APPEAL SUMMARY

Status: Decision Rendered - Reconsideration of ID 27601

Appeal ID: 27668	Project Address: 1735 E Burnside
Hearing Date: 4/13/22	Appellant Name: Thomas Ellicott
Case No.: B-008	Appellant Phone: 5035488674
Appeal Type: Building	Plans Examiner/Inspector: Catherine Heeb
Project Type: commercial	Stories: 3 Occupancy: A-2 Construction Type: V-B
Building/Business Name: Gold Record Hi-Fi Bar	Fire Sprinklers: Yes - full building
Appeal Involves: Alteration of an existing structure, Addition to an existing structure, Reconsideration of appeal, occ Change from Mixed B-R2 to A2	
LUR or Permit Application No.: LU# 21058141 DZ	
Plan Submitted Option: pdf [File 1] [File 2] [File 3] [File 4] [File 5] [File 6] [File 7] Proposed use: Nightclub

PROJECT NAME:
GOLD RECORD Hi-Fi BAR
1735 EAST BURNSIDE
CORNER OF: E. BURNSIDE AND SE 18TH AVE.

A2.8

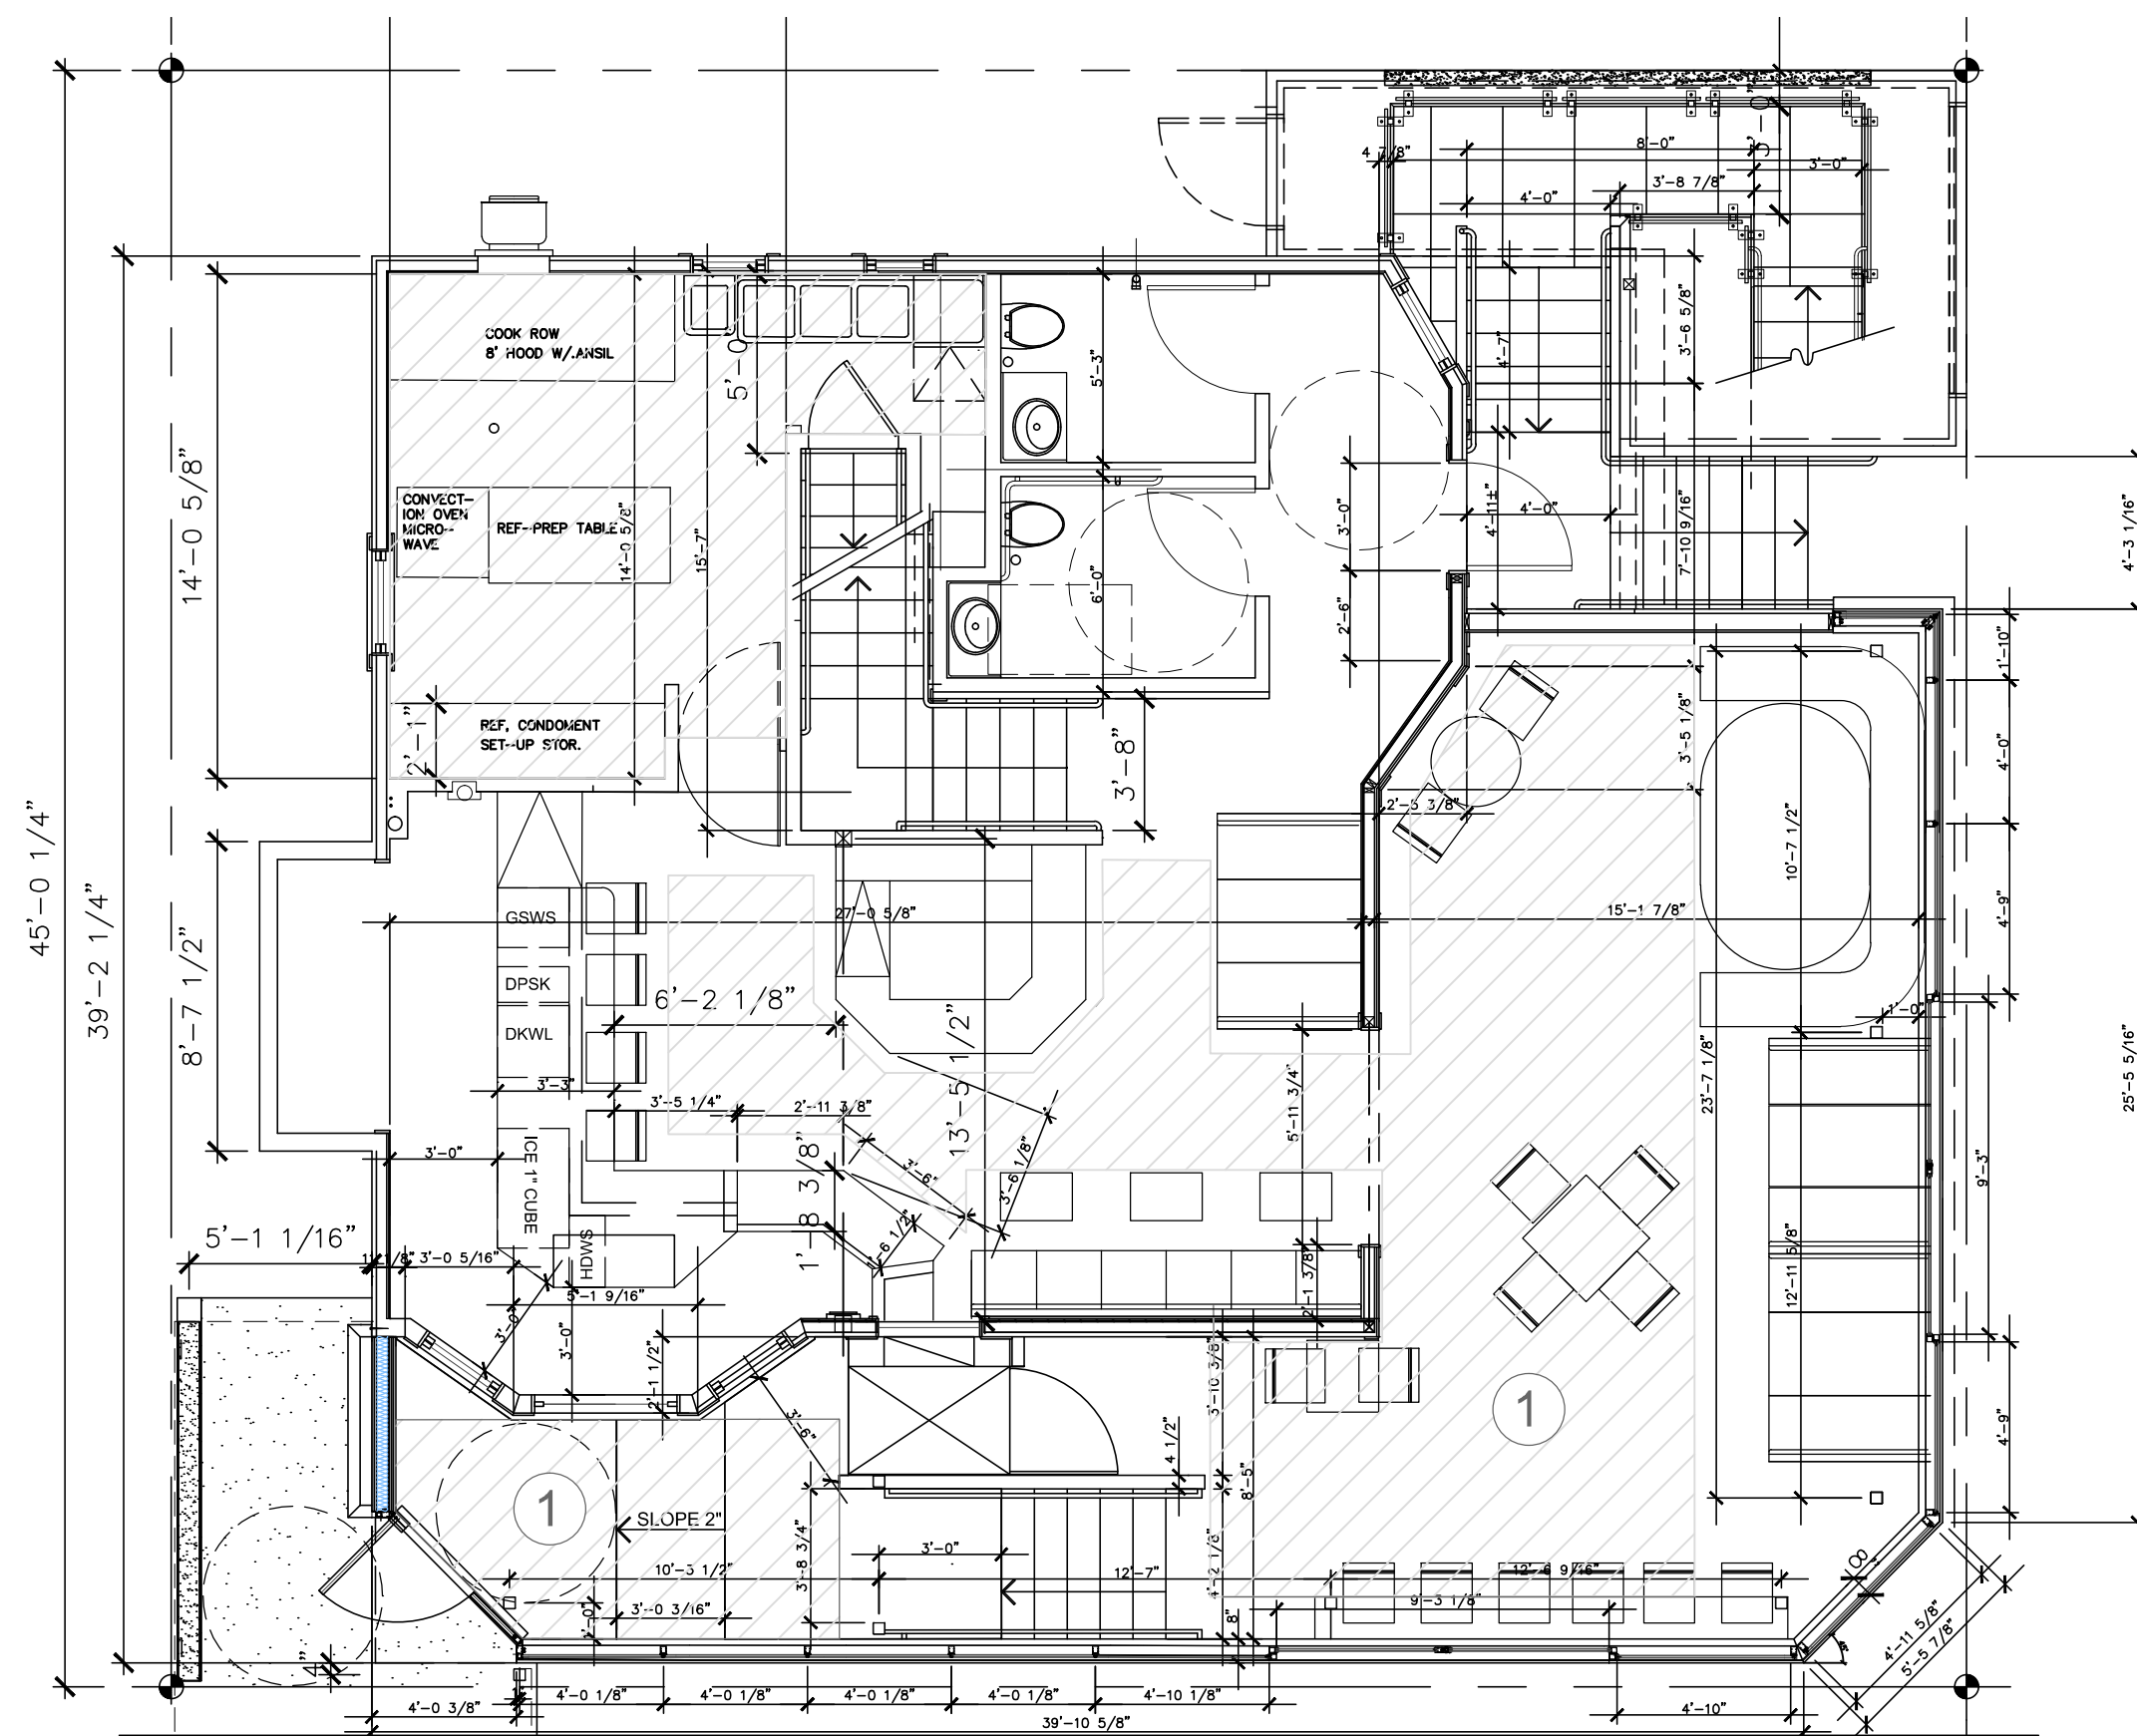
"Reconsideration Text": A second exit from a third floor is required to meet safe exiting requirements and is show in the attached drawing. The project is redesigned to meet building codes by compliance with table 1006.3.3(2).

1. Use of two exit access stairs to provide egress from 3rd floor to 2nd floor: Granted as proposed.
